SUBJECT: EQUIPMENT FURNISHINGS – COCKPIT ADDITIONAL ELECTRICAL SUPPLY – STATIC INVERTER – CAPACITOR C306 REPLACEMENT.

TRANSMITTAL: Service Bulletin 1830-25-37 Initial Release (Revision 1)

This page transmits Revision NO. 1 of Service Bulletin NO. 1830-25-37

Revision NO. 1 issued to revise Component Maintenance Manual references used throughout the Service Bulletin.

Figure B – Modification Status Label

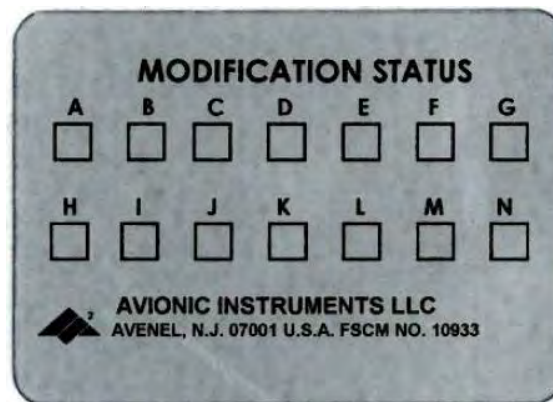
Upon completion of the modification described in this service bulletin, a “Modification Status” label is to be added to the top cover of the unit (See Figure B). The label is to be marked to indicate the modification status as level “A”.

Figure 1 – Top Cover View (Exterior Screw Locations)

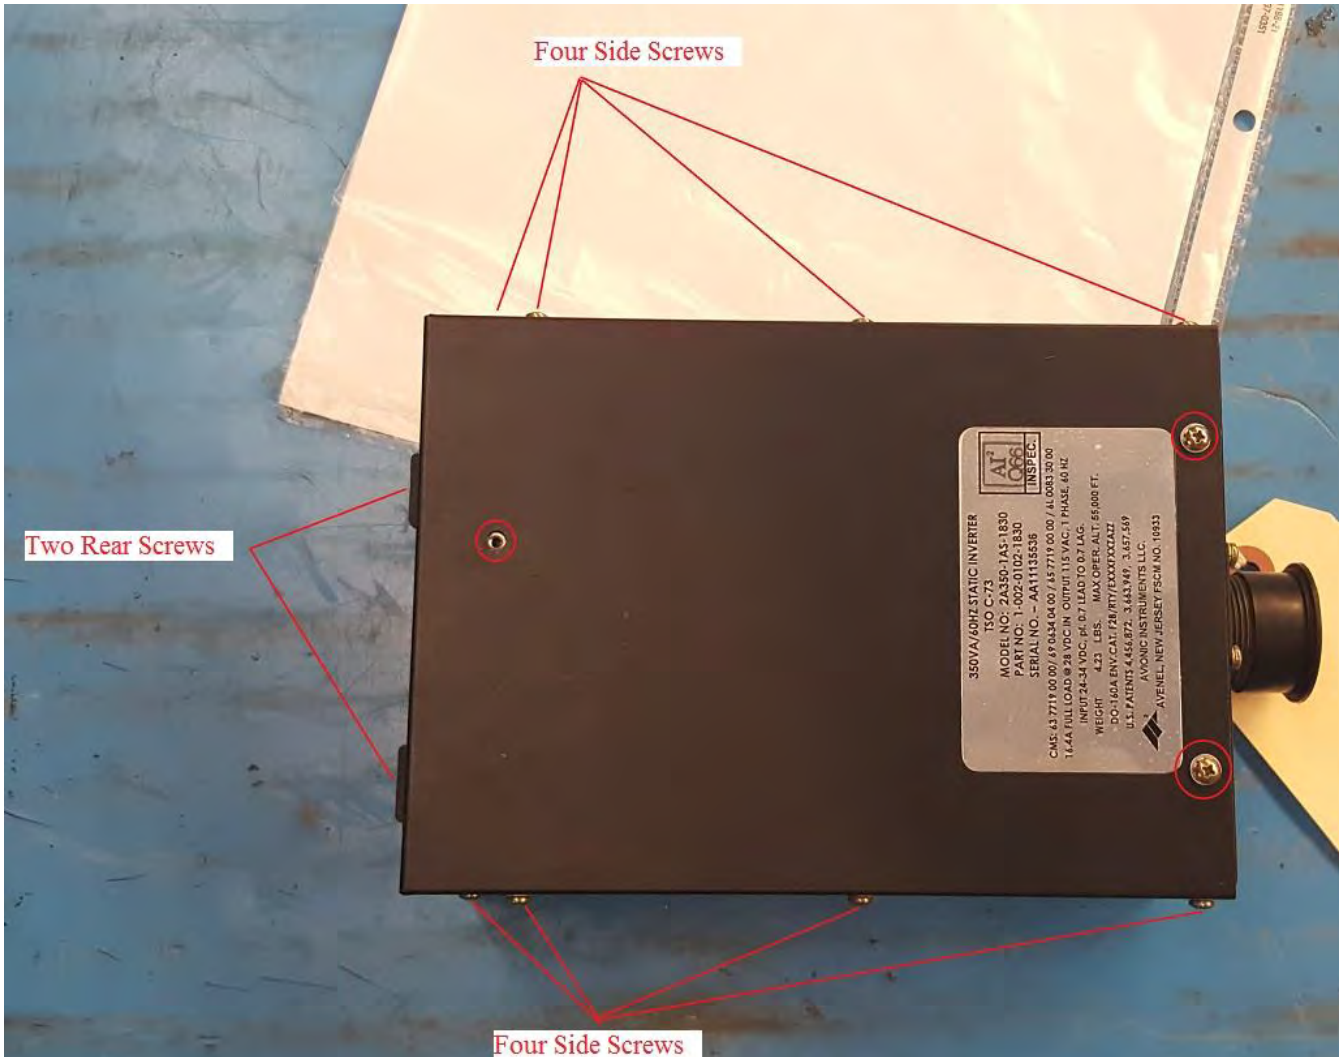
1. Remove three (3) top screws, two (2) rear screws and eight (8) side screws from the top cover of the unit. All screws in this step use washers (Figure 1).

Figure 2 – Top Cover removed (PCB Screw Locations)

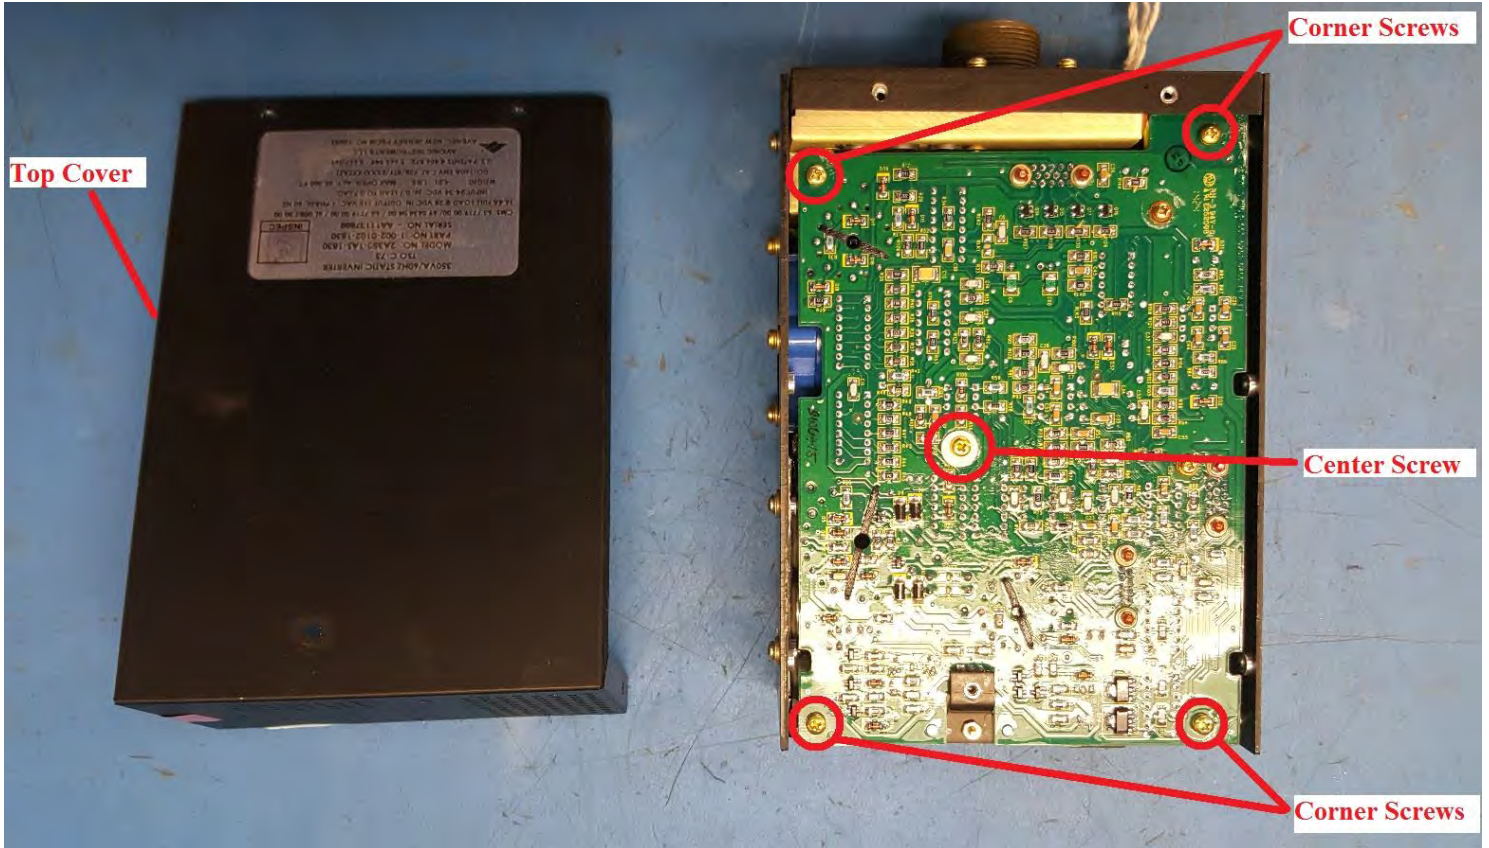
2. Carefully remove the top cover (Note: there may be a seal on the corners where the top cover meets the rear panel, remove this as well).
3. Remove four (4) corner screws and one (1) middle screw from the PCB. All screws in this step use washers (Figure 2).
